Committee of Adjustment

COMMITTEE OF ADJUSTMENT

254 Oakdale Avenue

Technical Report

PRELIMINARY SKETCH TO ACCOMPANY AN APPLICATION UNDER THE PLANNING ACT

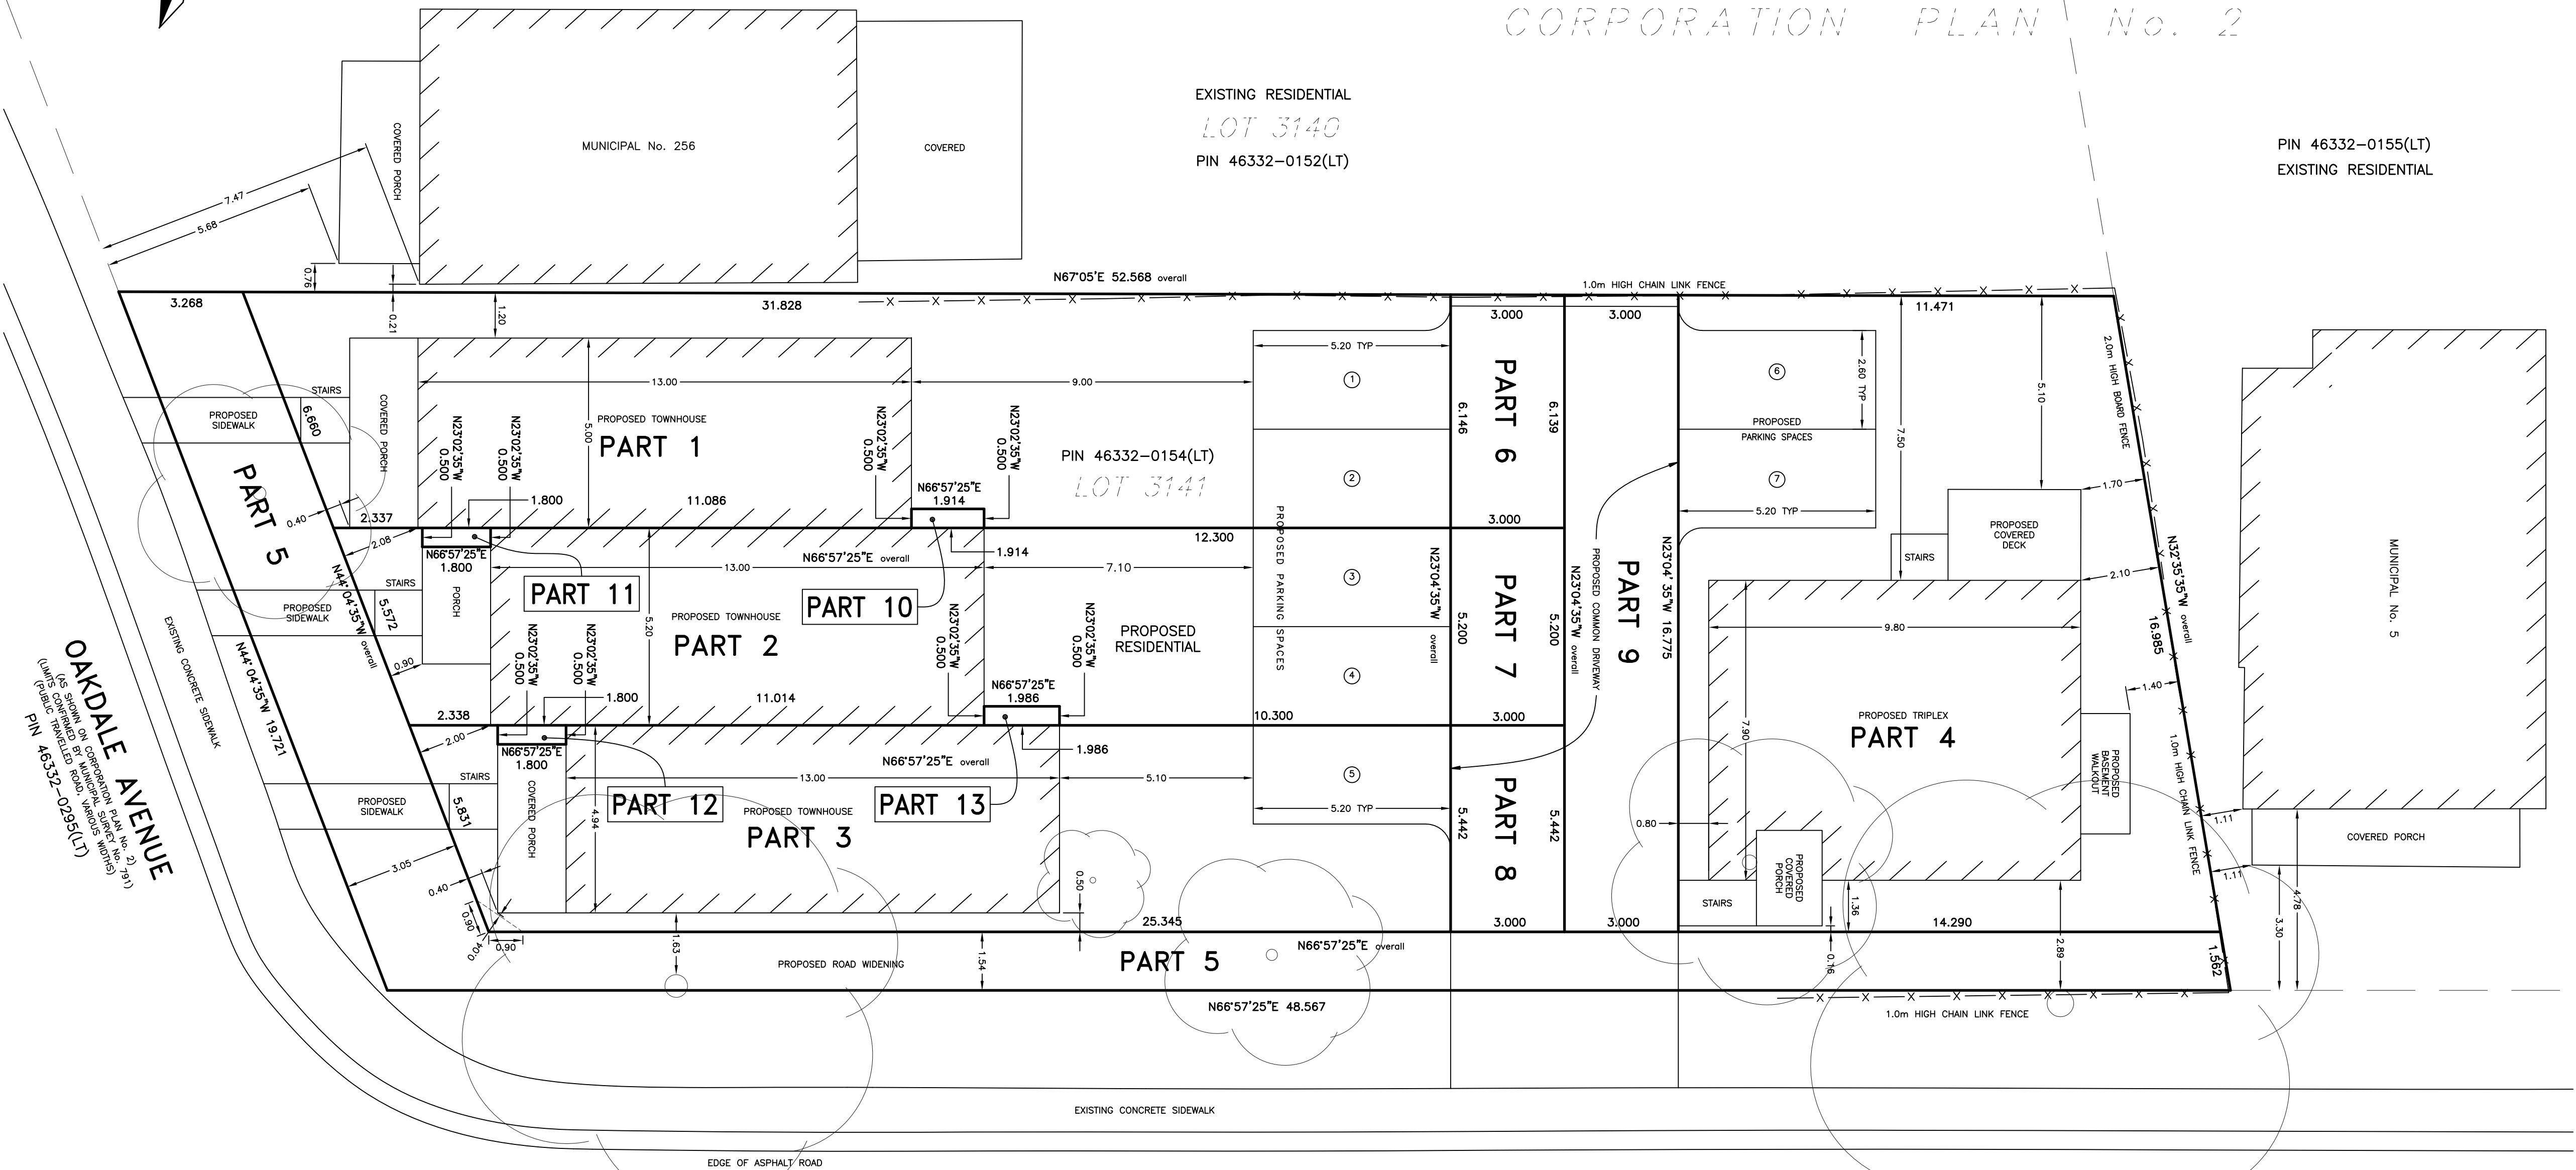
Comment(s): It is noted the Owner wishes to sever Parts 1 & 10, Parts 2, 11 & 13, Parts 3 & 12, Part 4, and Parts 6, 7, 8 & 9, for the construction three townhouse dwellings, a triplex dwelling, and access/egress rights over the above properties to the proposed benefitting owners, respectively, creating new lots on Oakdale Avenue and Capner Street. Part 5 is proposed to be dedicated to the City as a road widening, **however separate parts for the widenings along Oakdale Avenue and Capner Street must be accommodated.**

Oakdale Avenue is designated Collector Mixed-Use Corridor as per the City’s Transportation Master Plan, with a desired right-of-way width of 23.0m along this section. The City shall require a road widening along Oakdale Avenue of 3.048m in accordance with a widening previously acquired as per Plan 30R-8358 and transferred to the City free and clear of any encumbrances to be known as Public Highway *Oakdale Avenue*. A separate part for the Oakdale Avenue widening shall be identified further.

Capner Street is designated a Community Road as per the City’s Transportation Master Plan, with a desired right-of-way width of 20.0m. The City shall require a road widening along Capner Street of 1.54m in accordance with a widening previously acquired as per Plan 30R-14900 at 260 Oakdale Avenue and transferred to the City free and clear of any encumbrances to be known as Public Highway *Capner Street*. A separate part for the Capner Street widening shall be identified further.

The Silver Maple tree located on what is currently private property but will become public property once the required road allowance widening (Part 5 on the attached plan) is dedicated to the City. The tree is not a desirable specimen; it will need to be removed and stumped by the applicant prior to the City receiving the road widening.
